AIRWORTHINESS DIRECTIVE

Sikorsky S- 76 Series Helicopters

AD/S-76/71

Rotor Brake Disc

Figure 1 RBD Inspection Limits.

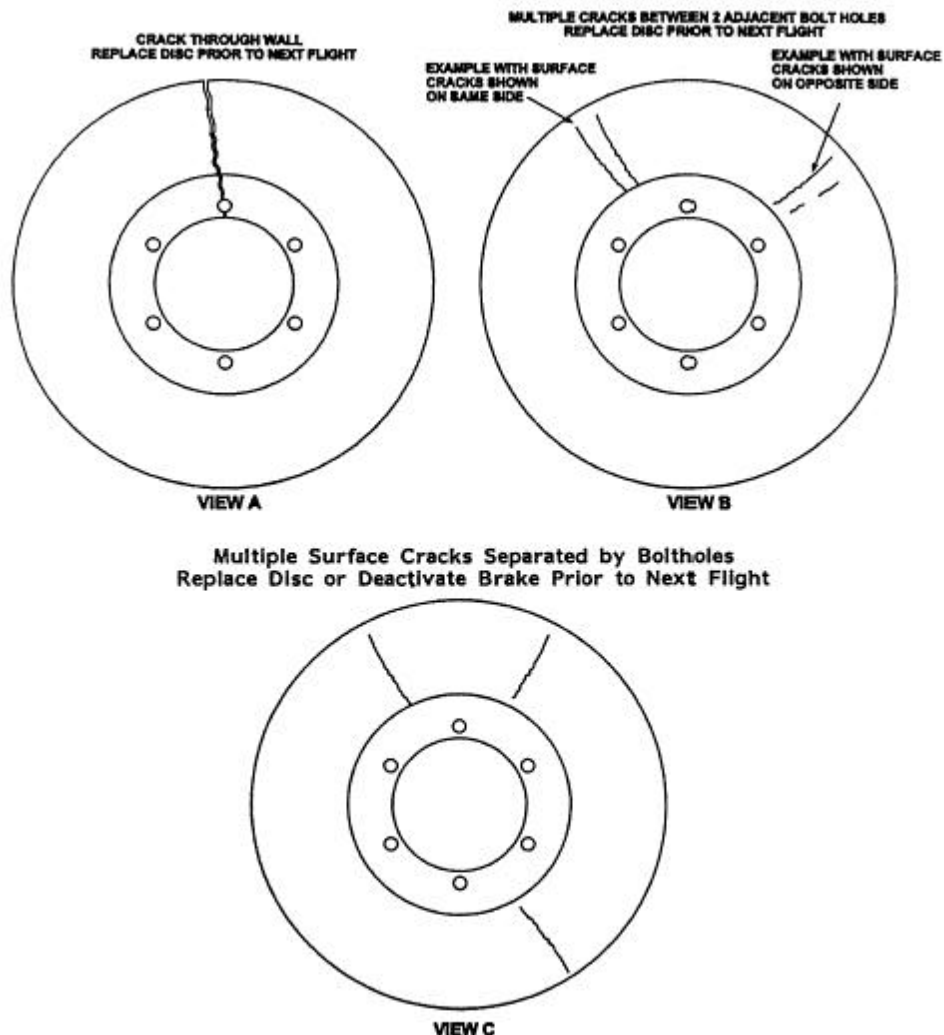
2. For RBD's with P/N 76363-0103-104, inspect the RBD for cracks as detailed in Figure 1.
 - a. If a crack is found extending through the entire RBD thickness as detailed in Figure 1, View A, replace the RBD with a serviceable RBD other than P/N 76363-09103-104.

- b. If 2 or more surface cracks are found located between adjacent boltholes as shown in Figure 1, View B, replace the RBD with a serviceable RBD other than P/N 76363-09103-104.

- c. If a surface crack, or surface cracks are found separated by boltholes as shown in Figure 1, View C, replace the RBD with a serviceable RBD other than P/N 76363-09103-104, or deactivate the RBD before further flight.

Note 1: Short "glazing" cracks are not a cause for rejection.

- 3. Replace the PHC RBD, P/N 76363-09103-104 with a serviceable RBD other than P/N 76363-09103-104.
